# SERVICE BULLETIN

## REPLACEMENT OF FUEL PUMP

### FOR ROTAX<sup>®</sup> ENGINE TYPE 912 (SERIES) SB-912-053

## MANDATORY

(see Fig.1)

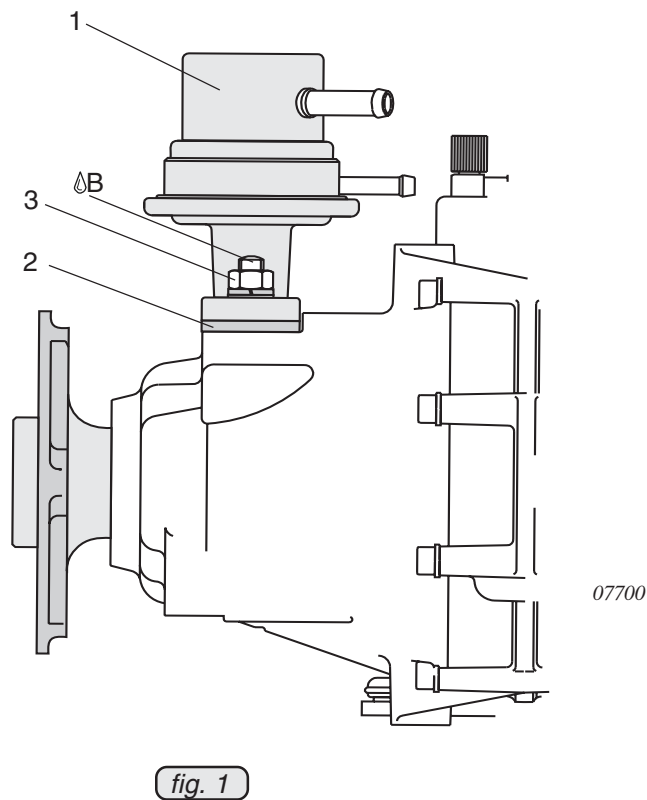
1. Remove fuel pump (1).
2. Gasket (2) replaced by new part.

■ **CAUTION:** Install new gasket supplied with new fuel pump. Do not reuse old gasket.

◆ **NOTE:** On the sealing surfaces of the gearbox housing and the fuel pump no sealing compound has to be used.

3. Install fuel pump.

4. Tighten uniformly hex. nuts (3) with LOCTITE 243. Tightening torque 15 Nm (133 in.lb).

◆ **NOTE:** The additional use of LOCTITE 243 should be applied at each removal/replacement of the fuel pump and/or gasket. A rework of already installed fuel pumps part no. 892542 and 892546 is not necessary.

5. Install fuel line.
